AMENDMENT OF SOLICITATION/MODIFICATION OF CONTRACT

2. AMENDMENT/MODIFICATION NUMBER
00073. EFFECTIVE DATE
04-05-2021

The purpose of this amendment is to provide the following:

1. A copy VA Addendum 2 combined document as well as the Addendum 2 Attachments and Narrative Documents.
2. A copy of 23 07 11 HVAC and Boiler Plant Insulation Document.
3. A copy of the Exterior Site Plan Dumpster Laydown Document.
4. A copy of the Minneapolis Mental Health Technical Questions Spreadsheet.
5. A copy of the Addendum 2 Revision Set 2
6. Technical question due date has been extended from April 6, 2021 to April 8, 2021 at 2:00 PM ET.

WON DOOR SUPPORT

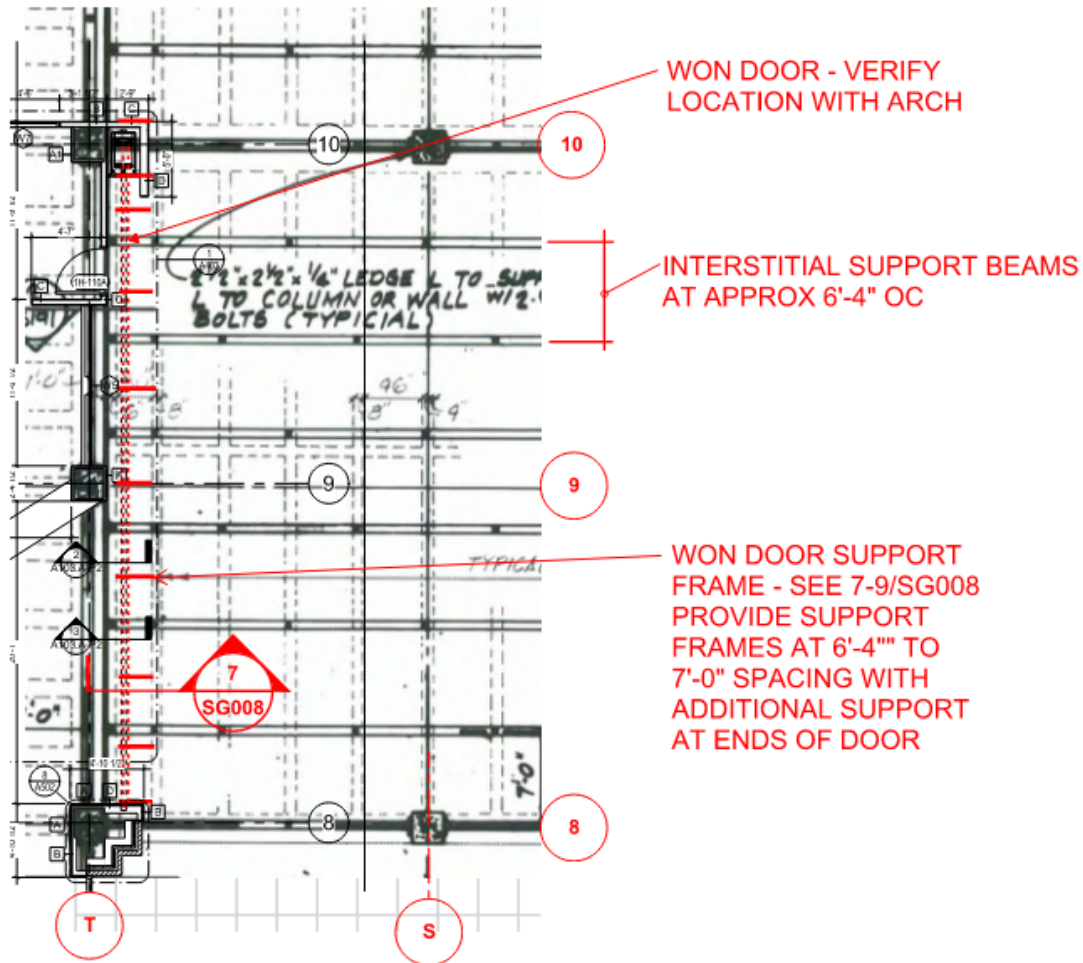
1. DETAILS 7,8,9: Details are for WON DOOR SUPPORT. Where details refer to plan, reference plan information below.

ACCORDION DOOR SUPPORT

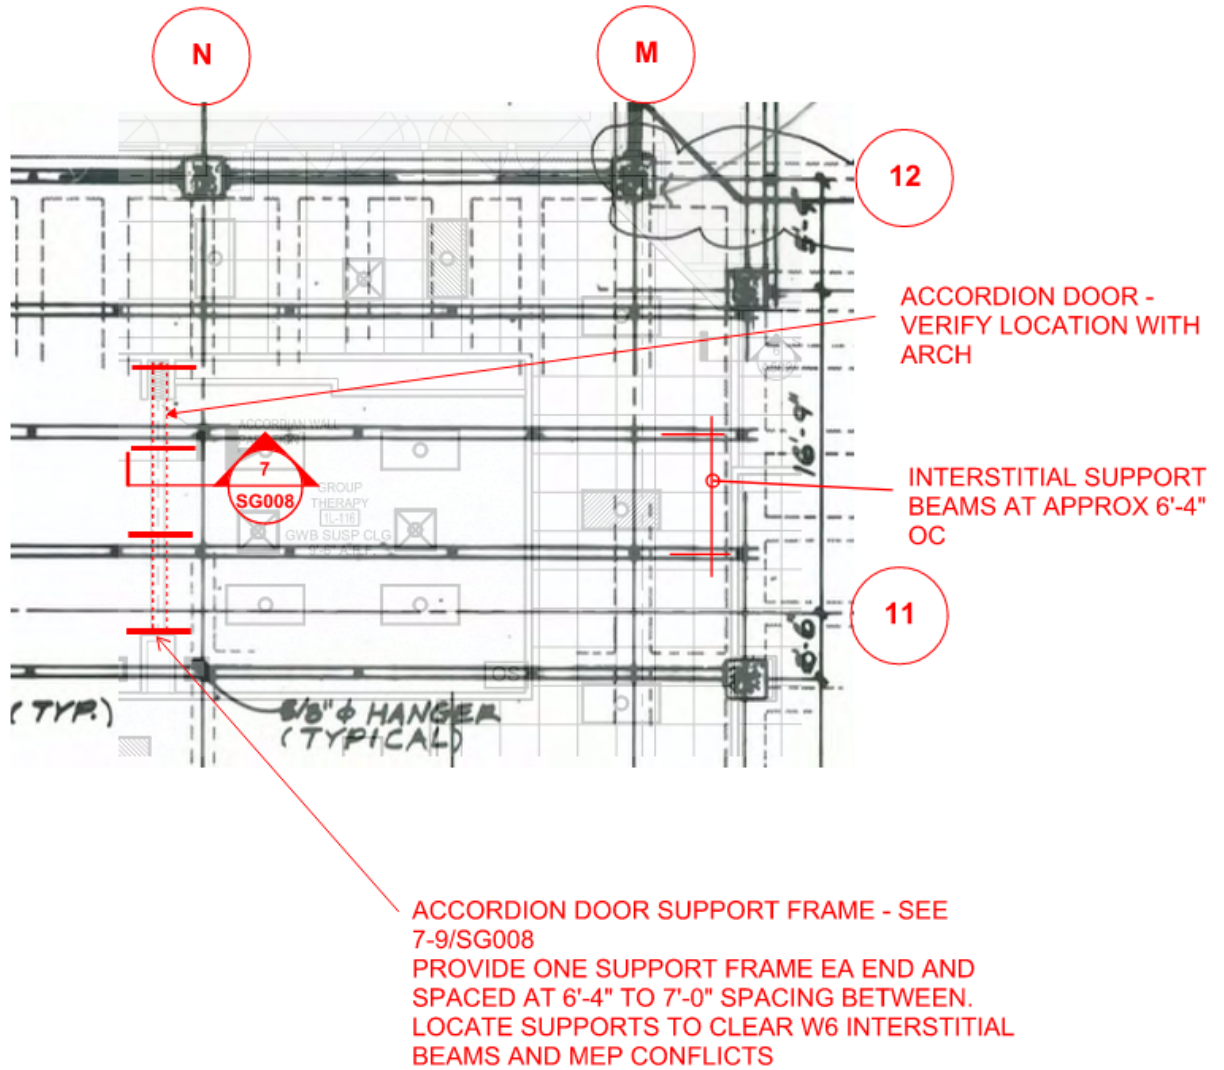
2. Refer to the plan information below for the structural support of the ACCORDIAN WALL PARTITION in phase 3, area L.

10 TYP INTERSTITIAL DECK PATCH (LESS THAN 4" DIA)
 3" = 1'-0"

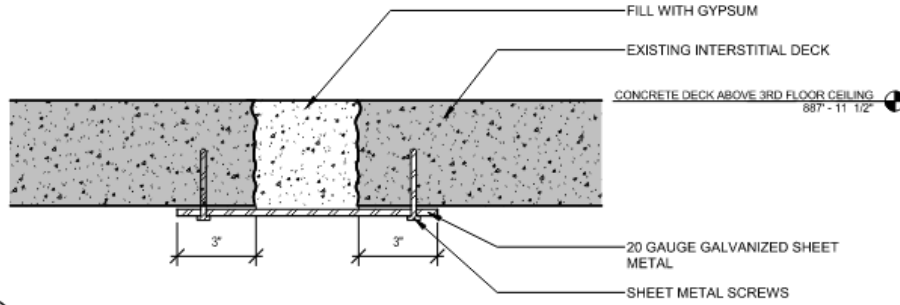
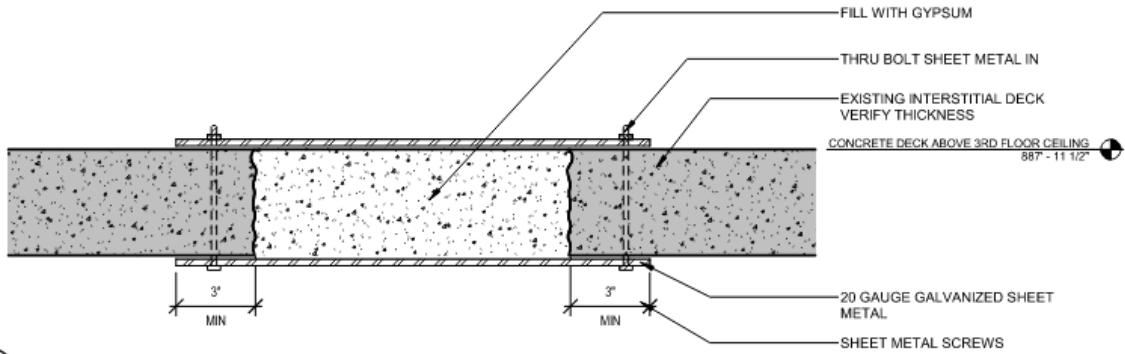
3. ADD the Details 10, 11 and INTERSTITIAL SPACE GENERAL NOTES provided below to this sheet.

INTERSTITIAL SPACE GENERAL NOTES	
1.	VERIFY EXTENT OF EXISTING PENETRATIONS THROUGH THE INTERSTITIAL BARRIER ONCE DEMOLITION OF MECHANICAL DUCTING, PLUMBING AND ELECTRICAL SYSTEM IS COMPLETE
2.	VERIFY PLANNED REUSE OF EXISTING PENETRATIONS BY MECHANICAL AND ELECTRICAL CONTRACTORS TO ESTABLISH EXTENT OF ABANDONED PENETRATIONS. REVIEW SURVEY / INVENTORY LIST WITH MECHANICAL AND ELECTRICAL CONTRACTORS.
3.	PATCH ALL ABANDONED PENETRATIONS THROUGH THE INTERSTITIAL BARRIER THAT ARE GREATER THAN FOUR SQUARE INCHES AS INDICATED ON DETAIL 11
4.	PATCH ALL ABANDONED PENETRATIONS THROUGH THE INTERSTITIAL BARRIER THAT ARE LESS THAN FOUR SQUARE INCHES AS INDICATED ON DETAIL 10
5.	VERIFY / COORDINATE SIZE AND LOCATIONS OF ADDITIONAL REQUIRED OPENINGS / PENETRATIONS IN THE INTERSTITIAL BARRIER. SAWCUT AND REMOVE BARRIER MATERIAL AT THESE LOCATIONS AS REQUIRED TO ACCOMMODATE DETAIL

FLOOR DRAIN IN EXISTING SLAB

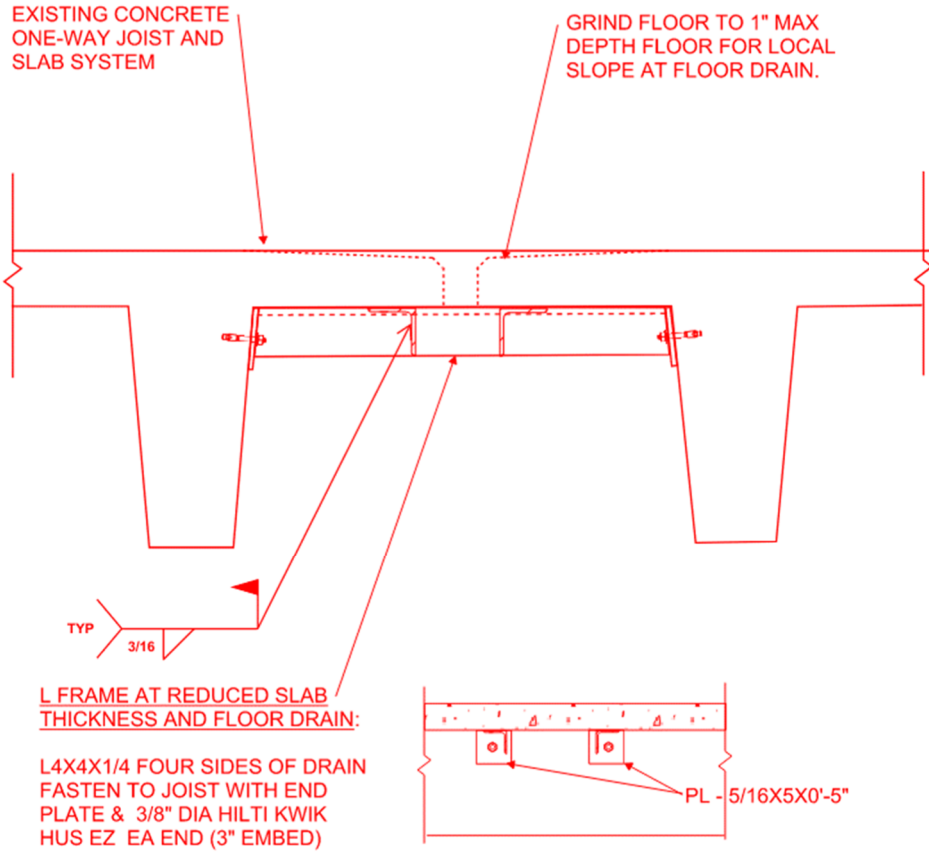
4. ADD to sheet detail 13, shown below: Shower Floor Recess for use @ STAFF LKR/TLT Rm 1H-105.

TOILET PARTITION SUPPORT

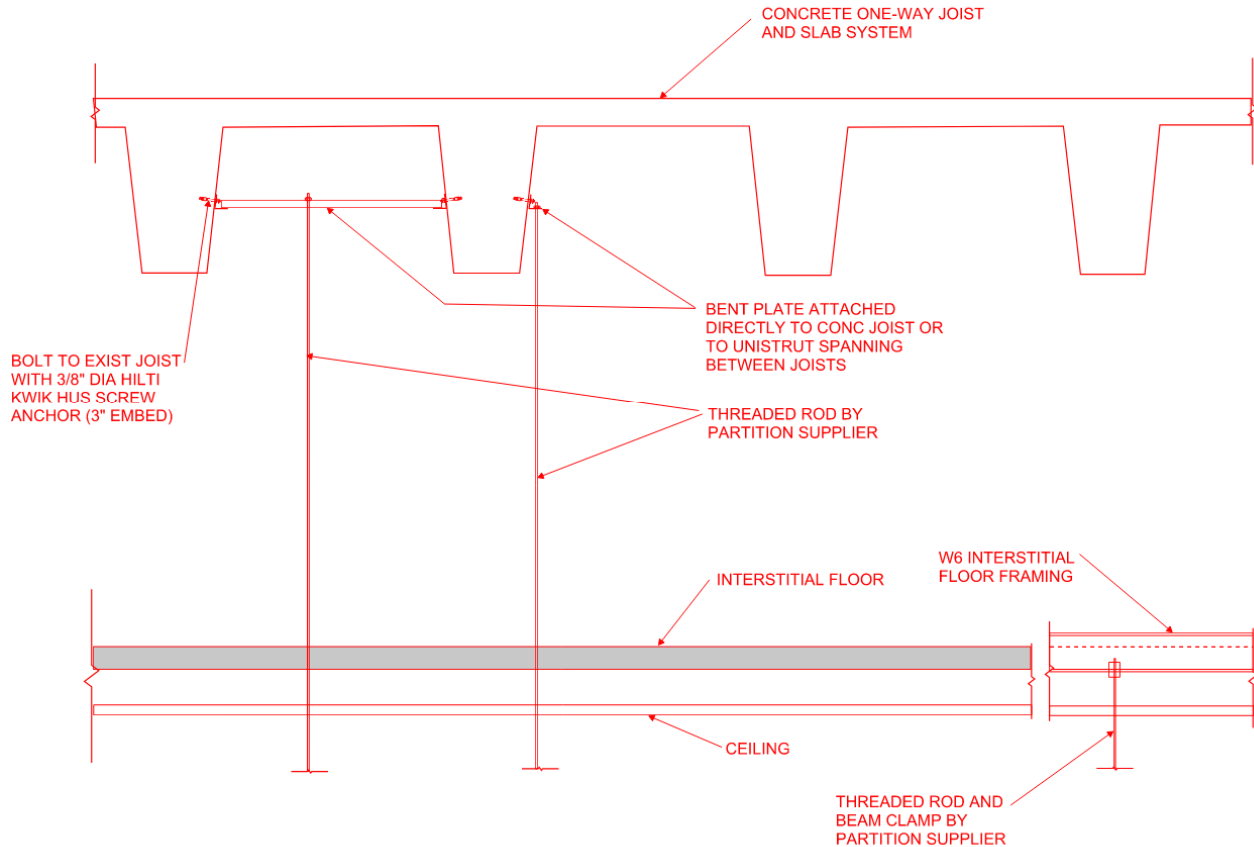
5. ADD to sheet detail 14, shown below: Toilet Partition Support @ STAFF LKR/TLT Rm 1H-105.

1 TYPICAL PARTITION CONTROL JOINT FRAMING AT DOORS
 1 1/2" = 1'-0"

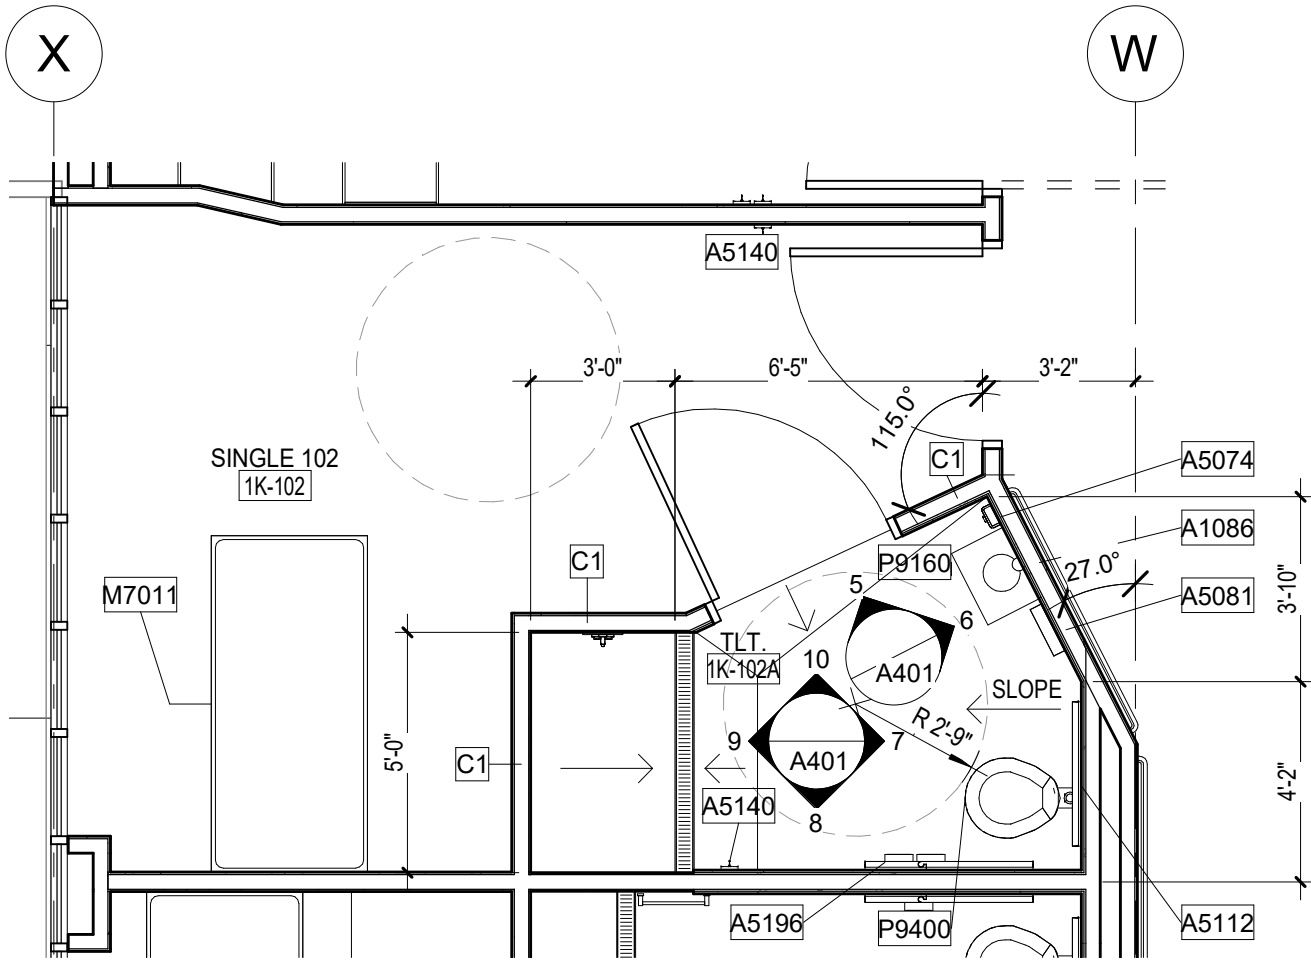
Sheet A002 New Detail 1: TYPICAL PARTITION CONTROL JOINT FRAMING AT DOORS
Sheet A401 Replace Detail 1 with Addendum 2, Sheet A401, Detail 1
Sheet A401 Replace Detail 2 with Addendum 2, Sheet A401, Detail 2
Sheet A401 Replace Detail 1 with Addendum 2, Sheet A401, Detail 3
